SUBJECT: KEWAUNEE NUCLEAR POWER PLANT - EXEMPTION FROM THE
REQUIREMENTS OF 10 CFR PART 50, APPENDIX G, APPENDIX H, AND
SECTION 50.61 (TAC NO. MA8585)

EXEMPTION

SAFETY EVALUATION BY THE OFFICE OF NUCLEAR REACTOR REGULATION
REGARDING AMENDMENT OF THE KEWAUNEE NUCLEAR POWER PLANT LICENSE
TO INCLUDE THE USE OF A MASTER CURVE-BASED METHODOLOGY
FOR REACTOR PRESSURE VESSEL INTEGRITY ASSESSMENT

Figure 3 - Plot of Available Data Sets Containing Both PCVN and 1T-CT or Larger Data to Estimate the Bias in PCVN T_0 Results as a (Potential) Function of the Constraint Parameter, M_0 for the PCVN data set.

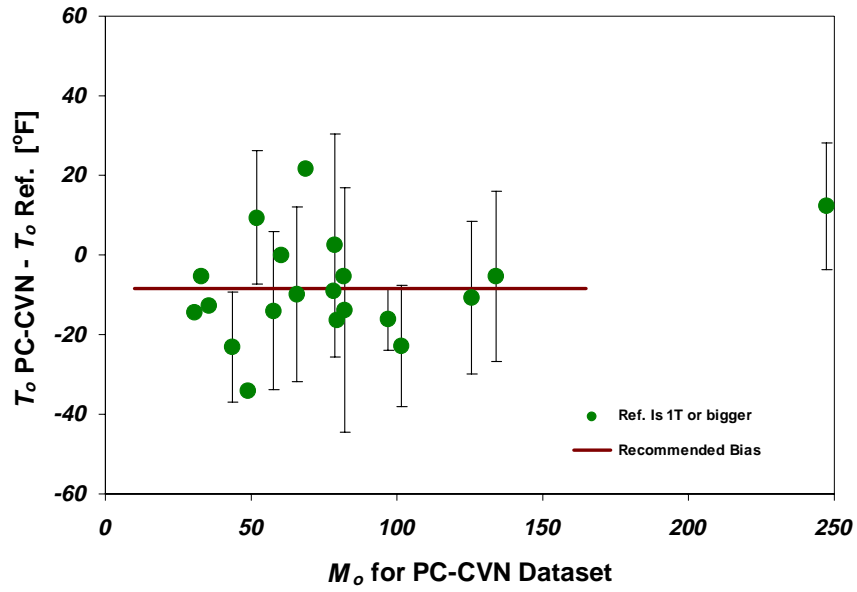
In Figure 3, “ T_0 PC-CVN” is the T_0 value determined for a particular material based upon the testing of PCVN specimen sets per ASTM E1921-97 (including the censoring limit) and “ T_0 Ref.” is the T_0 value calculated for the same material from larger specimens. Thus, the ordinate axis in Figure 3 represents the difference in calculated values of T_0 with negative

From Figure 3, the NRC staff concluded that although a statistically significant bias of 8.5 °F was evident in the data, no defined trend with M_0 was able to be resolved. The NRC staff also observed other data points for which " T_0 Ref." values could be calculated from specimens as small as 0.5T-CTs. With the inclusion of this additional data, a trend of increasing PCVN bias with decreasing M_0 may have been resolvable, but the complication of including data wherein the size (and thus the expected constraint) of the specimens used to define " T_0 Ref." was nearly the same size as the PCVN specimens would have made any such conclusions highly speculative. It can, however, be noted that with regard to addressing bias related to the licensee application, either interpretation would have yielded the same net effect in the NRC staff's overall methodology.

The NRC staff acknowledges that the lack of a definable trend in Figure 3 calls into question whether the observed bias from PCVN test results can be simply addressed as a matter of specimen constraint. Other theories have been postulated, including consideration of specimen geometry and T-stress, to explain the observed differences in PCVN and CT specimen results. The NRC staff recognizes that additional research in this area may help to better define this issue and modify the conclusions of this SE. However, the NRC staff concludes, at this time, that the assumption of a 8.5 °F bias in PCVN-based T_0 values relative to values obtained with larger size CT specimens, to be applied to each unirradiated and irradiated PCVN data set in the licensee submittal, is adequate to address this potential source of non-conservatism in the NRC staff's methodology as given in Appendix A to this SE.

The methodology developed by the NRC staff, however, includes sufficient flexibility to incorporate specific bias values for each of the four PCVN data sets relevant to this evaluation of the KNPP RPV circumferential weld should additional information demonstrate that different bias values are appropriate. To provide this flexibility, each of these four data sets must be addressed separately since the effect of bias on the evaluation of the shift in T_0 must be assessed given the NRC staff's methodology discussed in Section 4.3.2 above. As such, the effect of "accounting for bias in PCVN data" in the NRC staff's methodology cannot be easily discussed as a stand alone item, but must instead be presented as it is integrated into achieving results from the overall NRC staff methodology. This integration of bias into the NRC staff's methodology is addressed in Appendix A and discussed further in Section 4.3.5 below.
